32 Middlebrook Ave.  
 Add. & alb.  
 SHEET 3/3 COPY 2  
 CITY OF DURBAN  
 PLAN No. 574/3/72  
 APPROVED  
 DATE 30 MAY 1972

THIS PRINT FOR \_\_\_\_\_ DATE BY \_\_\_\_\_  
 ALTERATIONS TO EXISTING HOUSE  
 FOR T.W. PARKES ESQ  
 32 MIDDLEBROOK AVE VIRGINIA,  
 DURBAN  
 WORKING DRAWING  
 DRAWING NO 72-3-2  
 SCALE 1:50  
 DATE 22.3.72  
 DRAWN BY MIDDLEY  
 GOURLAY, HARRIS, FELS AND PARTNERS  
 ARCHITECTS AND TOWNPLANNERS  
 81 HIGHWAY HOUSE, 83 JAN SMUTS HIGHWAY,  
 DURBAN. TELEPHONE 886321

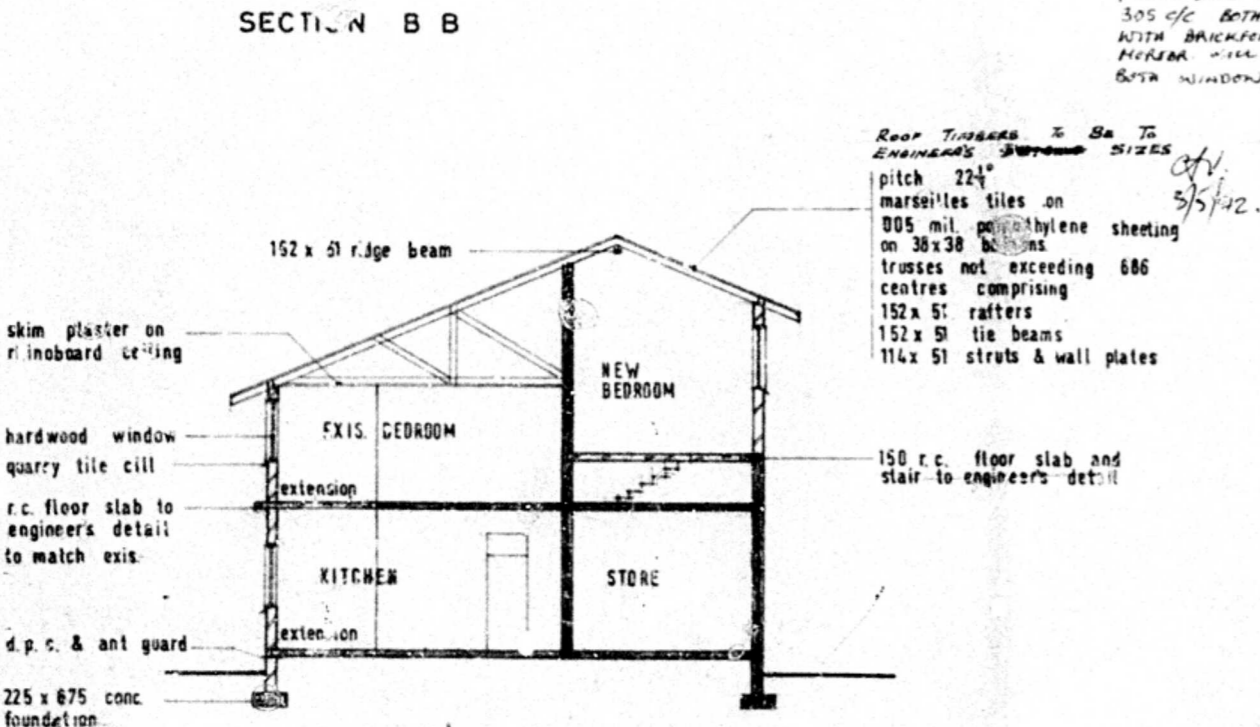
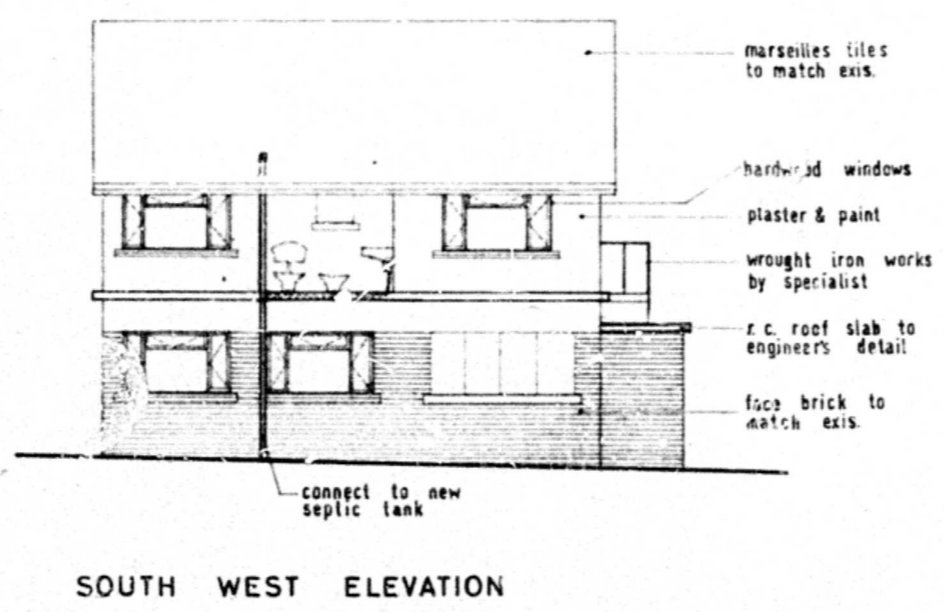
FLOOR SLAB TO BE REINF. WITH 6 RODS AT 305 C/C BOTH WAYS 2 CROS. OF BRICK REINF. WITH BACKFACE WITH SOLID JOINTS IN CENT. HEREIN WILL BE PROVIDED IN ALL WALLS & BOTH WINDOW CILLS & ROOF PLATE CORNER.

SECTION 108 OF BUILDING BY-LAWS TO BE COMPLIED WITH
